DAVID FLORIDA LABORATORY - BUILDING # 65 3701 Carling Ave., P.O.Box 11490, Station H, Ottawa, Ontario, K2H 8S2

## 9f023-20200546 Addendum No. 1

Project: Bay 3 HVAC Refit project No. CSA15-G8

Date Issued: March 10, 2021

This is subgrade drawing of Bay 3.

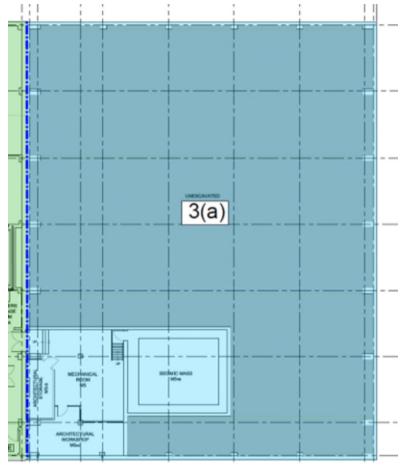
Is scaffolding/man lifts allowed on the flooring of the clean room?

Scaffolding and man lifts are allowed given that they do not exceed the floor loading limit. The limits are 250 pounds per square foot (PSF) for the large loading dock and 1,250 PSF for available Bay 3 construction areas (only slab on grade areas allowed). Note that only electric man lifts can be used within the building.

The area represented by the dark blue fill is the 1250 PSF load area. The area filled in light blue has a maximum load of 250 PSF. This sketch is not to scale and for approximation only. All measurements are to be confirmed onsite.

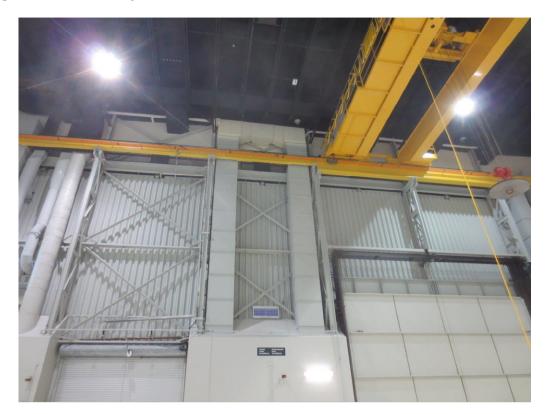
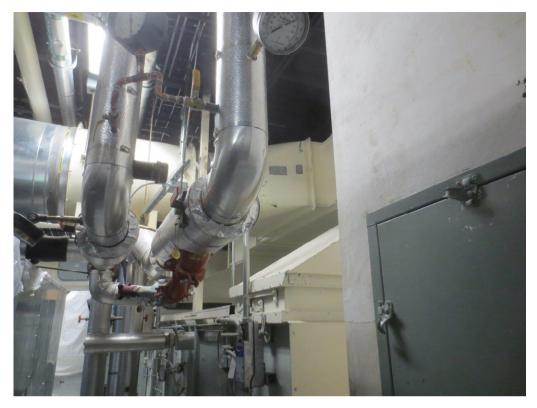
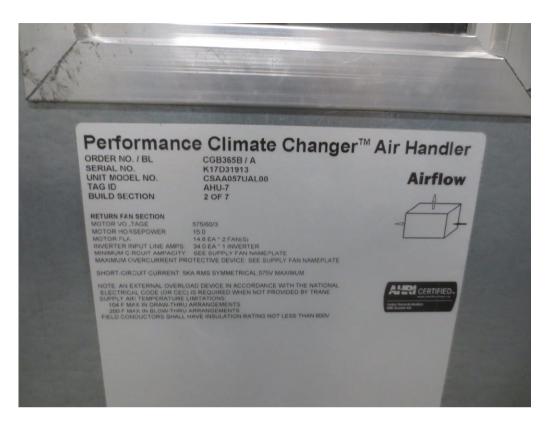
Could pictures of the existing AHU and the two new units be obtained?
